Access Compliance Report Public Rights-of-Way (Curb Ramps)

Main Street: HAZARD_AVE Cross Street: HAZARD_AVE Location: NW

ADA ID: RPRK211004153018 Ramp Type: Type 1 - Perpendicular Diagonal Initial Pass/Fail: Fail Overall Compliance: No Severity Score: 2

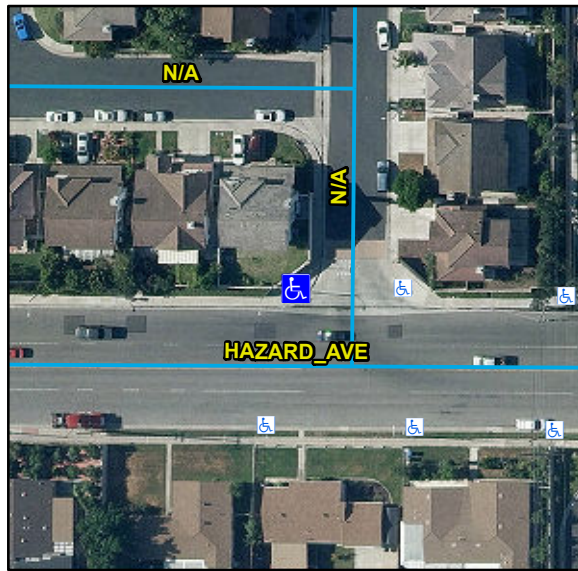
Compliance	Description	Data	Compliance	Description	Data
N/A	Ramp Length (in)	144	N/A	Flare Type LT	
Yes	Ramp Width (in)	48			N/A
Yes	Ramp Run Slope (%)	2.6	N/A	Flare Slope LT (%)	N/A
No	Ramp Cross Slope (%)	3.2	N/A	Flare Traversable LT	N/A
N/A	Landing Present	N/A	N/A	Flare Type RT	
N/A	Landing Length (in)	N/A			N/A
N/A	Landing Width (in)	N/A	N/A	Flare Slope RT (%)	N/A
N/A	Landing Run Slope (%)	N/A	N/A	Flare Traversable RT	N/A
N/A	Landing Cross Slope (%)	N/A	N/A	DWS Provided	N/A
N/A	Landing Movement Obstructed?	N/A	N/A	DWS Contrast	N/A
	Landing Movement Type	N/A	N/A	DWS Length (in)	N/A
N/A	Landing Shared	N/A	N/A	DWS Full Width	N/A
N/A	Clear Space	Yes	N/A	DWS Offset Left (in)	N/A
N/A	Clear Space To Crosswalk (in)	N/A	N/A	DWS Offset Right (in)	N/A
N/A	Marked Crosswalk 1	No	N/A	Marked Crosswalk 2	No
	Crossing 1 Direction	S		Crossing 2 Direction	E
	Marked Crosswalk 1 Width (in)	N/A		Marked Crosswalk 2 Width (in)	N/A

N/A	Ramp Inside Crosswalk 1	N/A	Yes	Ramp Inside Crosswalk 2	N/A
	Crossing 1 Slope (%)	2.7		Crossing 2 Slope (%)	3.4
	Crossing 1 Cross Slope (%)	1		Crossing 2 Cross Slope (%)	0.7
N/A	Gutter Ponding	N/A	No	Curb Slope	20.1
Yes	Gutter Lip Height (in)	0		Road Run Slope (%)	6
N/A	Gutter Run Slope (%)	N/A		Road Cross Slope (%)	5.3
N/A	Gutter Cross Slope (%)	N/A			
Yes	Overall Surface Condition: Acceptable		Yes	Perp Joint Present	Yes
	Cross Gutter Present?	Yes		Spandrel Present?	Yes
	Replace Cross Gutter?	No		Replace Spandrel?	No

Remove & Replace Curb Ramp With Two New Directional Ramps or Equivalent.
